INDESIT company

BCS333AVEI
BCS333AVEIS

F027597
F027598
F029153
F029154

Notices

0522067: SEALS FOR DOORS FOAMED AS ONE PIECE

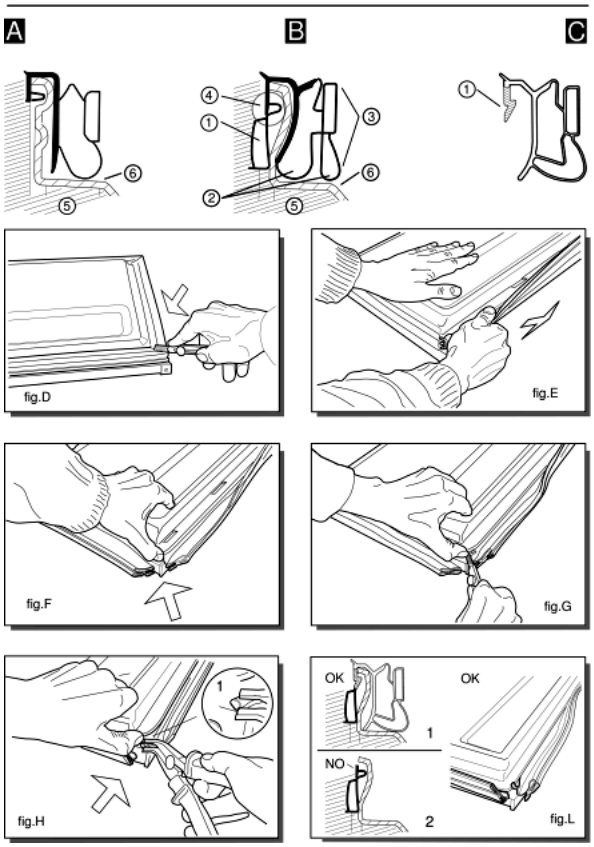
Various types of gaskets with different profile, as shown in figures (A) and (B), are used to fix the door (fig. A-5; B-5) and the inner door (fig. A-6; B-6) on the block foamed doors of combined freezers and refrigerators.
---Ilpea profile 245; 179; 412 (fig.A)
---Ilpea profile 287 (fig.B)
When replacing gaskets with profiles 245; 179; 412 these are fixed with screws (2 per corner) to the door.
Gaskets with profile 287 can not be used as spare parts but are designed to house the Ilpea type 900 gaskets (see figure C).
When replacing the gasket (287), once it is removed you will find a pocket (fig. B-1) between the door and inner door.
The rigid tooth (fig.C-1) of the gasket (900) is inserted inside between the pocket and the inner door, doing away with the need for screws.
Gasket with profile 287 is easy to identify since it has an exterior double edge (fig.B-2) which acts as a cushion when the door is closed.

To replace this gasket, follow these steps:
---Dismount the door and cut the four corners of the gasket along the joint (fig.D);
---lift the gasket and pull it carefully along its full length without tearing it (fig.E).
The purpose here is to detach the inner door slightly from the foam along the exterior edge for a depth equal to that of the gasket (fig.B-3);
---lift the corner of the inner door slightly, prising it up with your thumb (fig.F). Do not use a tool which might break the inner door;
---continue cutting the gasket inside the inner door for about 6 mm (fig.G);
---push in the tip of the pliers (type USAG N131) and pull outwards until you see the top edge of the pocket (fig. B-4) which is empty (fig.H-1);
---if you carry out this operation correctly (fig.L) you will be able to pull off the top edge of the pocket for the full length of the door.
If the gasket tears before the top edge (fig. L-2) you should repeat this operation from the other corner of the door.

---once the gasket (287), has been removed the space above the pocket (fig. L-1) can house the rigid tooth (fig. C-1) of the gasket 900.
When you fit this gasket ensure that it lies flush against the edge for the full length of the door.
If the rigid tooth is difficult to fit, eliminate any residues of foam between the door and the inner door in the gasket area.
fig.5131549A

n1030064: Elimination of sensor cage on 2002 range built-in fridge-freezers models BCS313

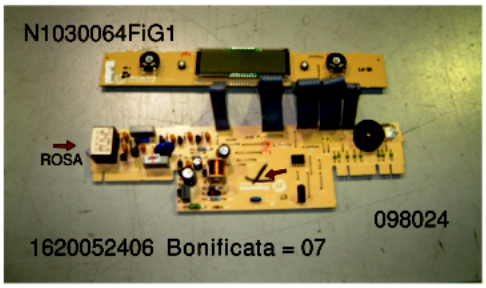
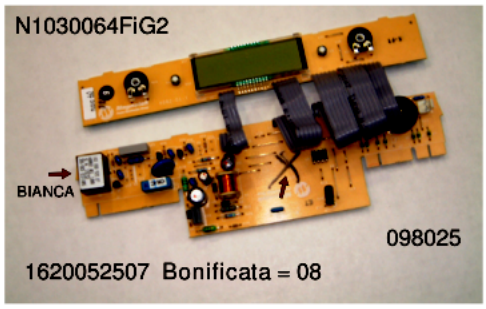
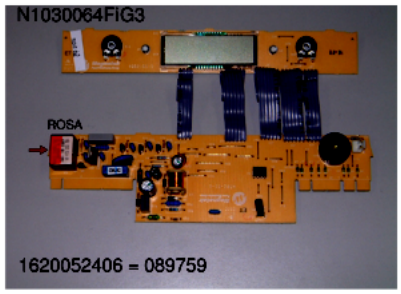
In April 2003 (serial no. 30407.0001) the Carinaro factory eliminated the cage protecting the fridge air sensor and moved the sensor 5-6 cm back on Ariston built-in electronic fridge-freezers.

This structural modification has involved the use of new electronic cards with warmer setting, because the sensor is less sensitive in the new position than in the previous more forward position with cage.

The Magnetek cards 162000524… (4083/PINK) and 162000525… (4082/WHITE) currently in stock in the Fabriano spare parts warehouse have all been replaced in order to be aligned with that used by production to date. These cards have been highlighted (see photo) with the marker pen, while the Magnetek codes (not higher than 162000524.06 and 162000525.07) are shown on the plates.
They will be managed with the following new Sat codes to enable correct ordering with respect to the previous ones.

The previous cards, with colder settings, do not have any highlighted marks and continue to be managed with the same Sat code (089759 and 088529=143093 ROHS) and must only be used on models with fridge air sensor in forward position and complete with cage.

Also, card 16200084501 will be managed with code 088529=143093 ROHS (4082/GREEN), currently used on the self-supporting fridge-freezer, which has the same settings as the previous card 16200052507 (4082/WHITE); whereas a card with red stamp on the pink plate (see photo) will be managed with code 089759.

Since November, electronic cards, with warmer settings, give the code 16200052407 for 4083/PINK and 16200052508 for 4082/WHITE on the plate, and must only be used on models with fridge air sensor without cage and in the back position.

.
New parts
098024 = (143091 ROHS) CARD (MAGNETEK 4083/PINK) new (no-frost models without cage)
098025 = (143092 ROHS) CARD (MAGNETEK 4082/WHITE) new (static models without cage)

Parts replaced
089759 - CARD (MAGNETEK 4083/PINK) 220-240/50 + red stamp (no-frost models with cage)
088529 = (143093 ROHS) CARD (MAGNETEK 4082/PINK) 220-240/50 (static models with cage)

n1030072: New 220-240V /50-60 Hz fan unit C09R1907 (KIT 077159 and 081971) Carinaro

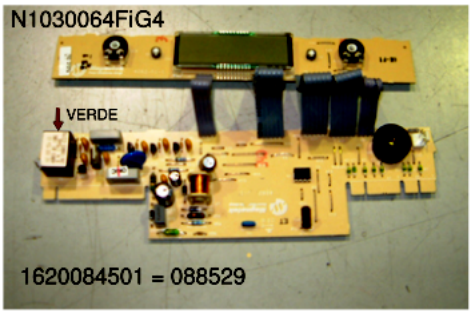
At the end of March 2004 the Carinaro factory replaced the fan unit in kit 077159.

The new fan unit (C09R1907) differs from the previous one (C09R1846) in the rpm reduction from 2290 to 2000, 3.5 Watt power, Class B, 220-240V/50-60 Hz voltage and faston connectors (6.3x0.8 mm) remain the same.
This modification will also be extended to the Melano and Setubal factories for Kit 081971.
The new fan unit will be managed with the same Service code as the previous one (076024), once the stocks of the latter run out; the same will also be done for Kits 077159 and 081971.

N130084FIG1

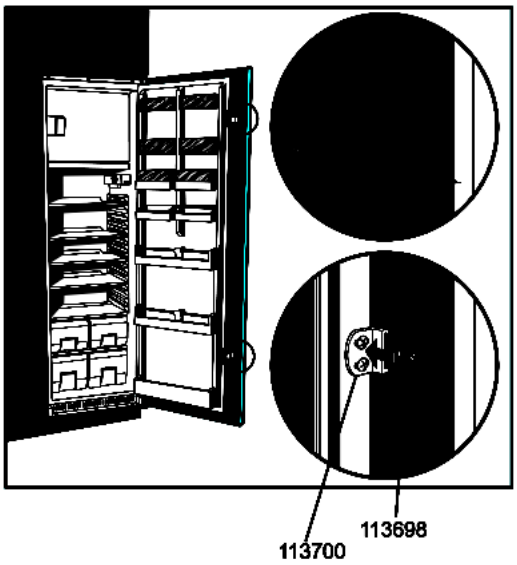
n1030084: New sliding blocks for fixing the furniture door to the refrigerator door

Since October 2004, the Carinaro factory has been using new sliding blocks for fixing the furniture door to the refrigerator door.
The new items are fixed to the side of the refrigerator door, whereas the previous ones were fixed to the front.
The doors are no longer provided with sixteen 2.6 mm holes on the front for fixing the old slides.
The new sliding blocks can also be fitted on premodification models. Proceed as shown in the attached figure (N1030084fig.1).
When replacing the sliding blocks on premodification models it will necessary to replace both guides.
This modification has involved changing the installation KITS

New parts

113698 - LARGE NYLON HOLDER SLIDE
113700 - NYLON HOLDER SLIDING GUIDE

Parts replaced

021258 - SMALL WHITE SLIDE + COVER
021259 - WHITE SLIDE
